COMPETITION RESULTS 28/09/2022

#1 March Studio

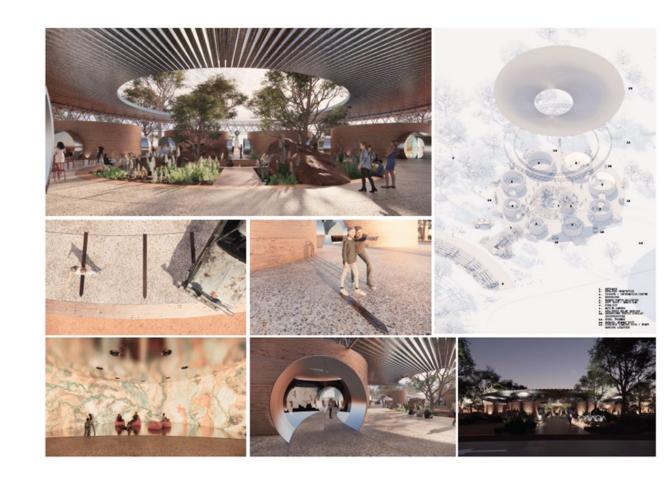
The Jury celebrates the concept by March Studio and unanimously places it first. Its character, functionality and chosen materials are considered to meet the program's call for an exemplar building, with an innovative but simple and agile design that will stand the test of time.

The seamless and organic forms, the honesty of the material selection and detailing in addition to the obvious physical connections to the surrounding landscape, ensure human scale and approachability of the built form. The exhibition spaces proposed are considered with development, to present a unique curatorial opportunity.
